**ADDENDUM NO. 7**

ITB 2019-095  
Demolition and Construction  
Prince Frederick Volunteer Fire Department (Company 2)  
Prince Frederick, Calvert County, Maryland

**ADDENDUM 7 - SK7.2**

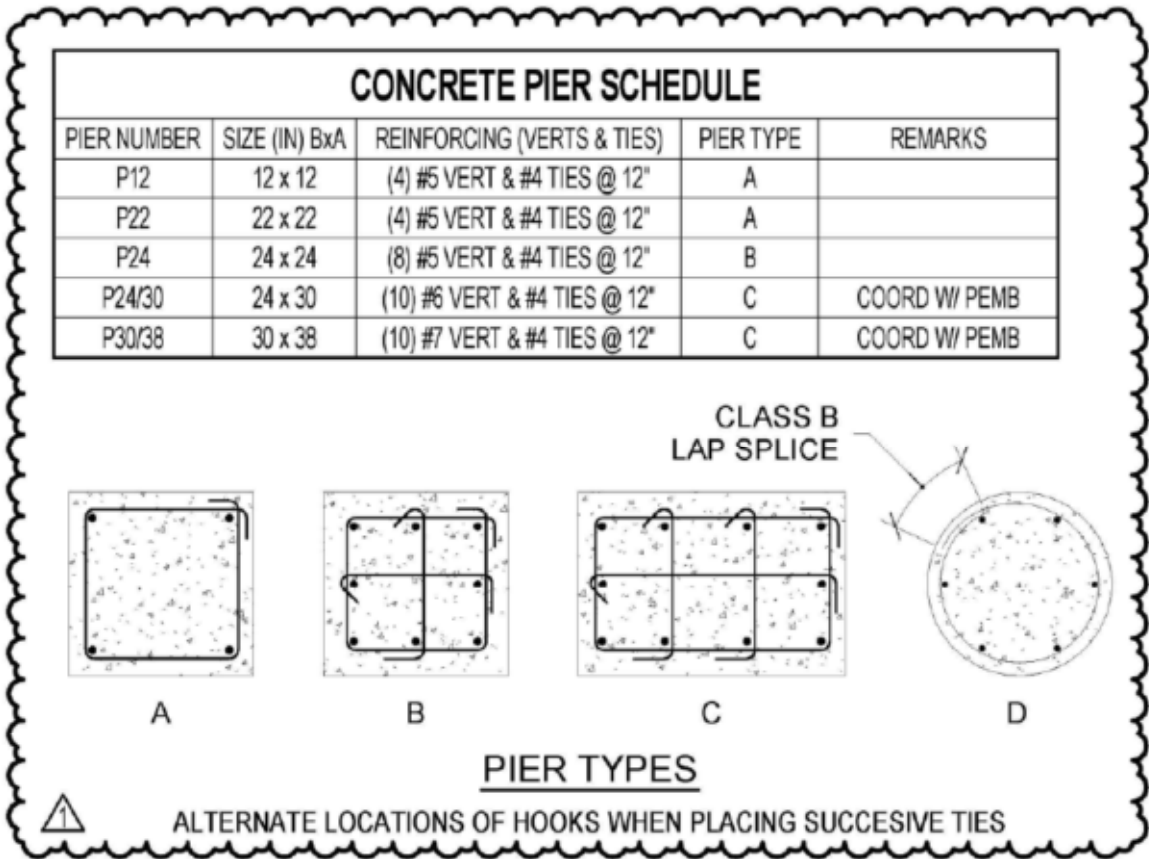
**S1.01 & S1.01A**

Revised Note 1 Under "Notes." See SK7.2.

REVISIONS AND ADDITIONS TO REINFORCEMENT  
NOTES ON S1.01 AND S1.01A

**ADDENDUM 7 - SK7.3**

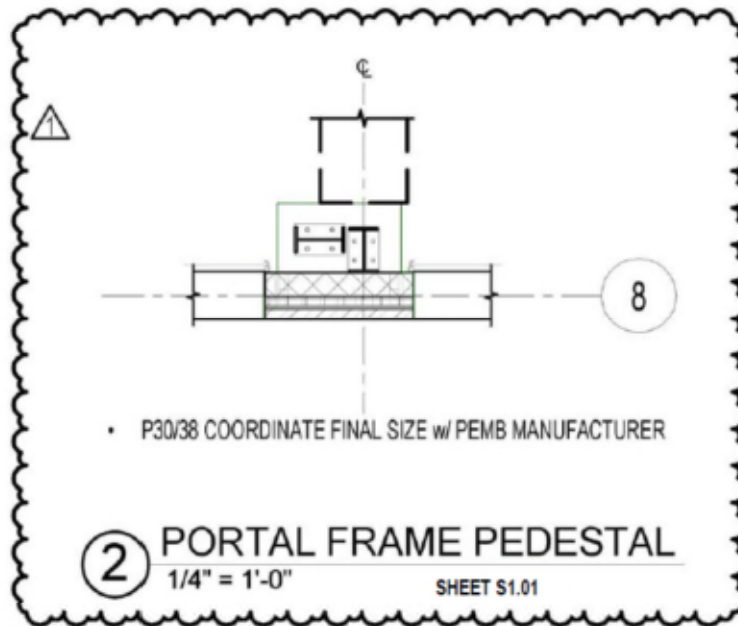
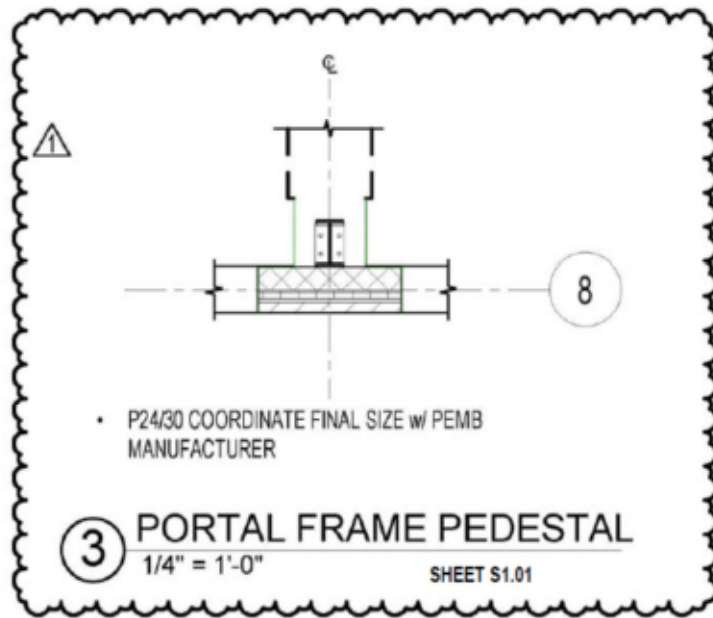
**S7.01**

Revised pier schedule. See SK7.3

② WEST ELEVATION - SK7.5  
1/8" = 1'-0" DETAIL 2/A2.01

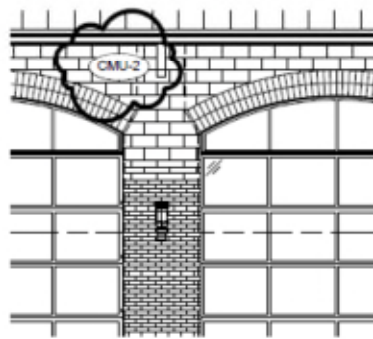
**A2.01**

Revised Materials Legend

Revised material note on 2/A2.01
